**North Anna 3
Combined
License
Application**

**Part 10: Tier 1/
ITAAC/Proposed
License
Conditions**

Revision 8

June 2016

North Anna Unit 3 Specific Figure 2.13.1-1 Sh 1. Unit 3 Electric Power Distribution System Functional Arrangement

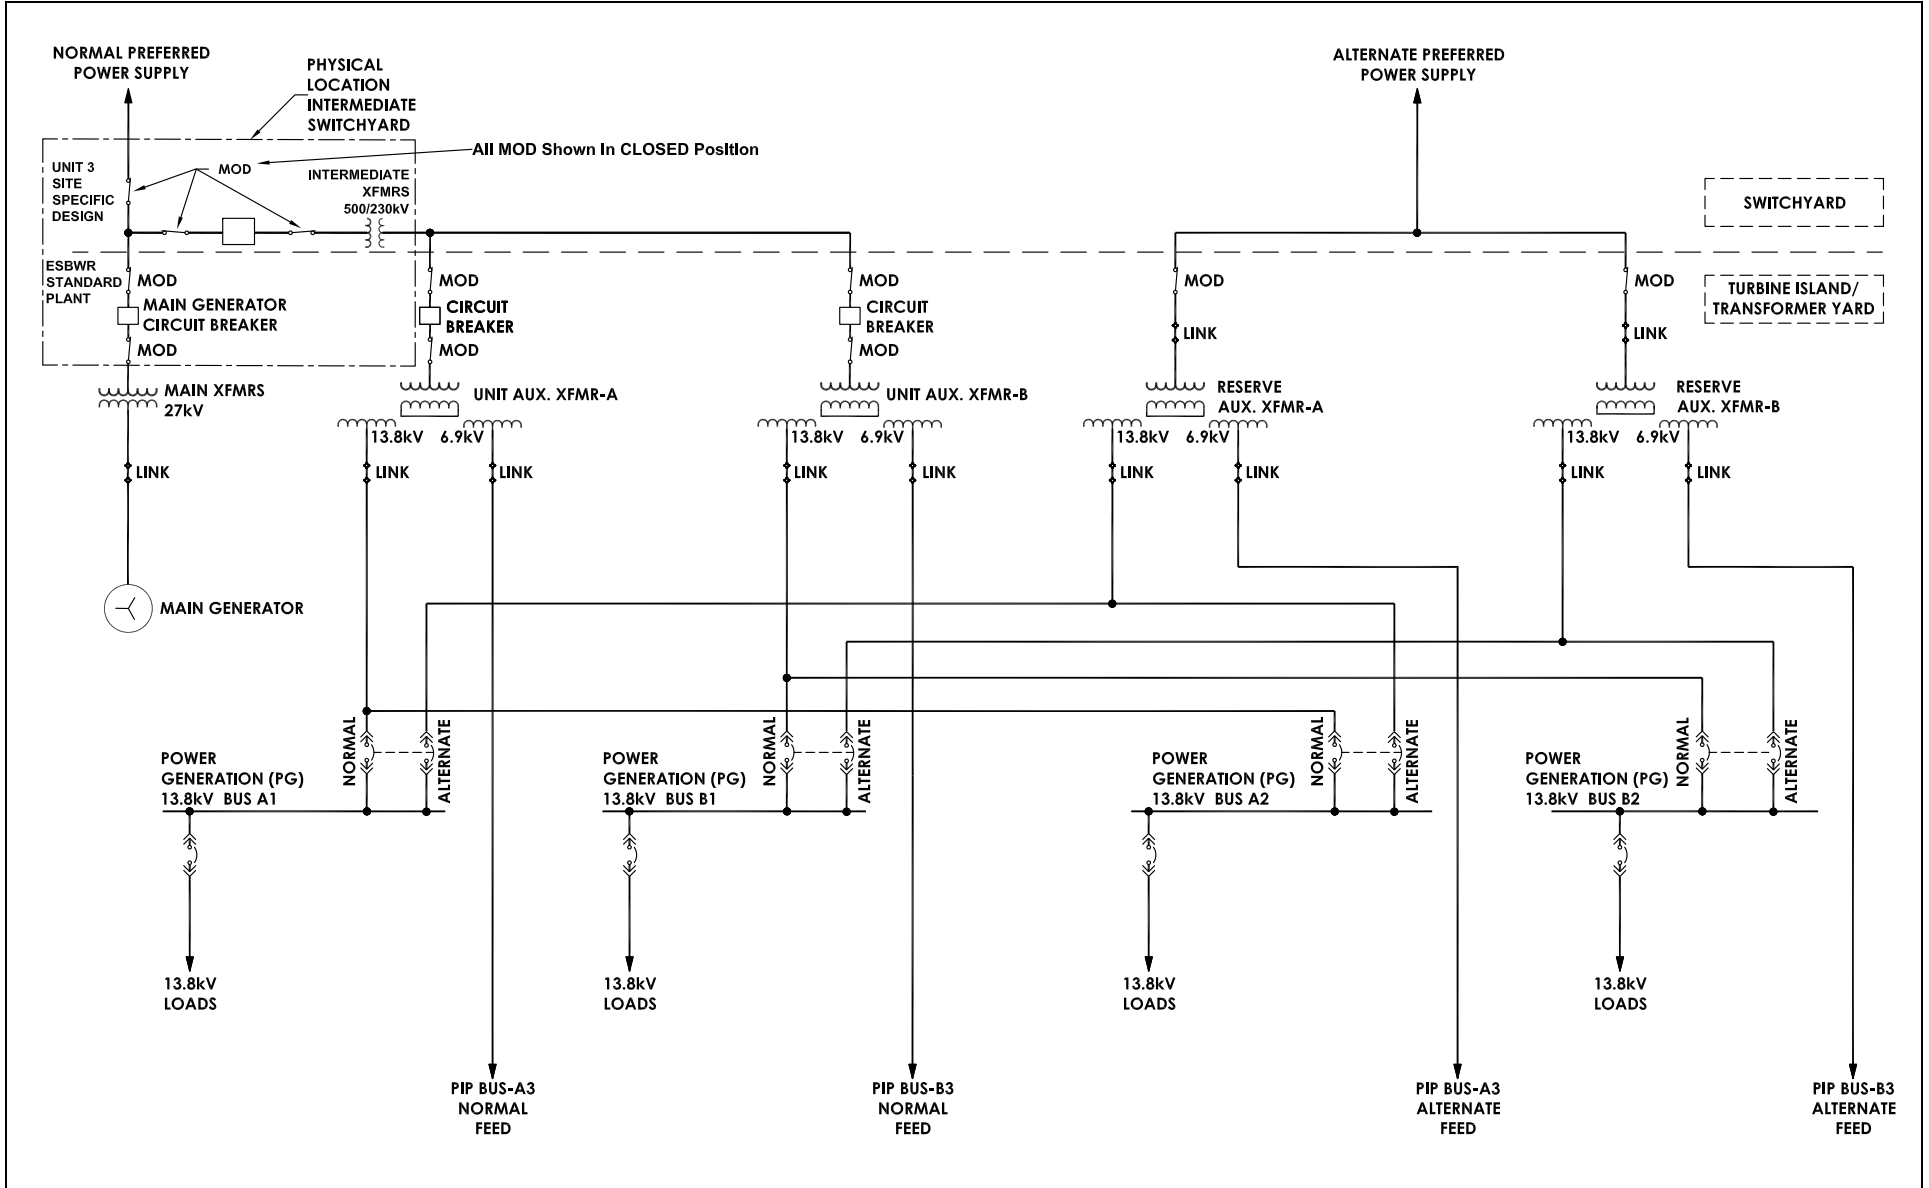
There is a departure from [DCD Tier 1, Section 2.13.1, Figure 2.13.1-1, Sheet 1](#), as described in [COLA Part 7](#). The Unit 3 Electric Power Distribution System Functional Arrangement is as shown on the next page, which provides the North Anna Unit 3 Specific Figure 2.13.1-1, Sheet 1. This Unit 3 specific figure replaces [DCD Tier 1 Figure 2.13.1-1, Sheet 1](#), where the figure is cited in [DCD Tier 1, Section 2.13.1](#).
